Ref RM210630 - RM210633

**RE: Further Information Request for Resource Consent Application No. RM210630 - RM210633 – 35 Lot subdivision in the Residential Zone and associated land use, earthworks, and stormwater consents – 166 Mapua Drive, Mapua**

**Figure 1:** Pre and post development 2-year ARI 2-hour event

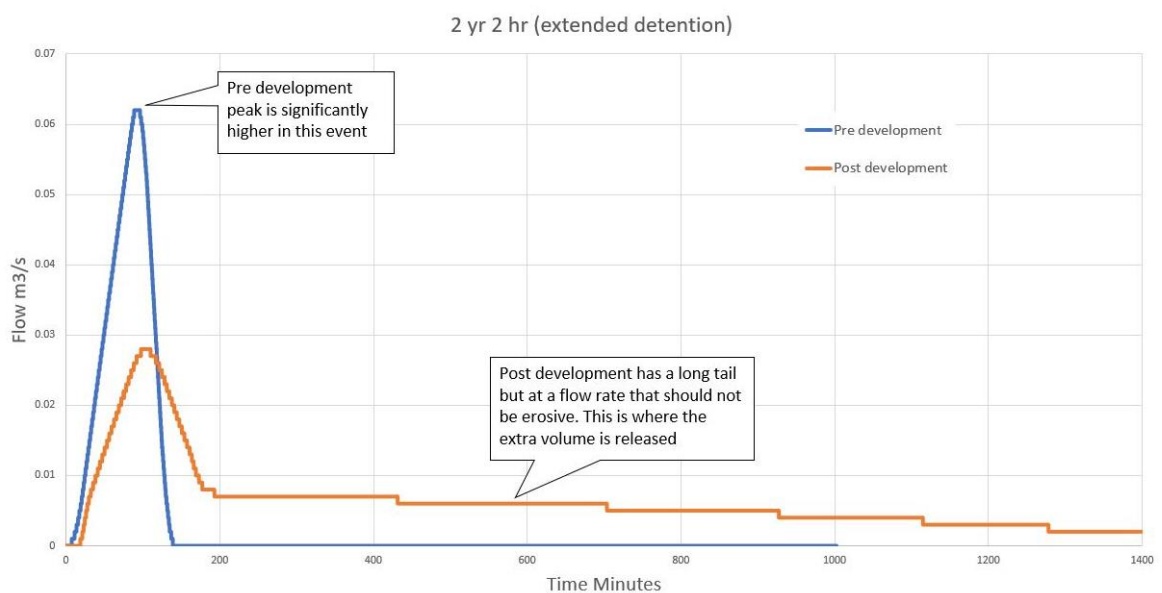
11. Please provide an assessment of how the proposed changes to stormwater run-off from the subject site following the proposed development may affect the hydrology of wetland 2382. Currently run-off is discharged in a diffuse manner across the site, but the proposed stormwater management will change this to a point source discharge from one point on the property. Please also include calculations for the likely increase in total stormwater volume likely to be discharged as a result of the proposed development during Q10 and Q100 events and provide an assessment of any effect this increase in total volume may have on the wetland.

In a 2-year ARI 2-hour event the peak flow is significantly different for the pre-development situation (Figure 1). So, although the post development case (Table 1) releases more total volume it does so at a low flow rate, less than 10 L/s, which will not increase flow in the receiving watercourse enough for it to start eroding and cutting down.

**Figure 1:** The first flush event (a 10 mm/hr rainfall with a total depth of rainfall of 25 mm) released from the stormwater pond

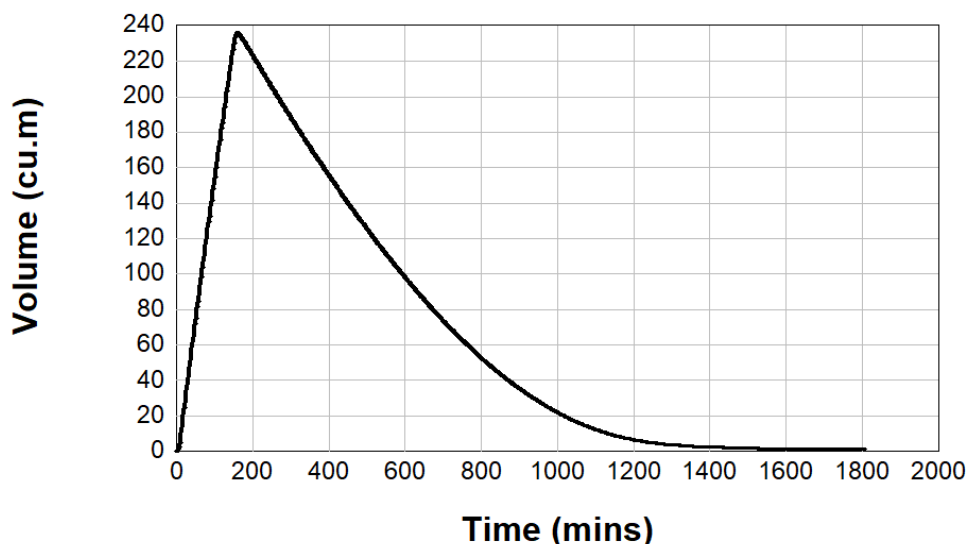
14. *The Envirolink report provided states that stormwater contaminants are likely to be minimal but provides little evidence to support this claim. Given the sensitivity of the receiving environment Council's Resource Scientist – Freshwater Ecology considers that further assessment of likely stormwater contaminants and potential effects on wetland 2382 is required.*

*The first flush event (a 10 mm/hr rainfall with a total depth of rainfall of 25 mm as specified in the NTLDM) will be released over about 20 hours. Figure 3 shows the water stored in this event in the basin and the time it takes to drain out. This will allow for some settlement of sediment, where it would be anticipated to remove down to about a 0.01 mm particle but more likely a 0.015 mm particle i.e. medium silts. Contaminants associated with urban development, such as copper and zinc are predominately attached to the sediment fraction, therefore removal of sediments, particularly during first flush events will reduce the contaminant load to the wetland. Therefore, a combination of a low risk of contaminants being generated, reducing the source of contaminants (such as dealing with using unpainted or treated building materials such as copper or zinc roofing materials at the construction phase), and attenuating the first flush fraction of medium silts within the stormwater detention pond indicate that any adverse effects from stormwater contaminants on the wetland are likely to be minimal.*
